# Historic Preservation Design Review

June 23, 2011

## HP-11-19, 15 N. Main St. (City)

**Request:** Design Review for proposed rear exterior renovations

Gutter Supply's **Heath**  
front view (top) and  
side view (bottom)

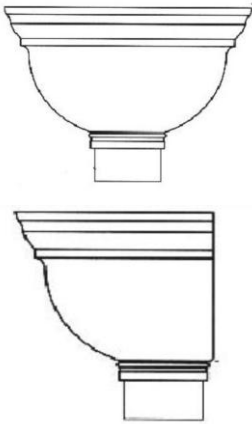
The two existing leaderheads (conductor heads

that collect water from the roof through pipe conduits in the upper-story wall) and downspouts are painted to match the rest of the rear façade. The leaderheads are to be replaced with aluminum collectors by Gutter Supply Co. (Lake Bluff, IL) model “Heath,” (15” x 9” x 10”) with round aluminum downspouts to match.
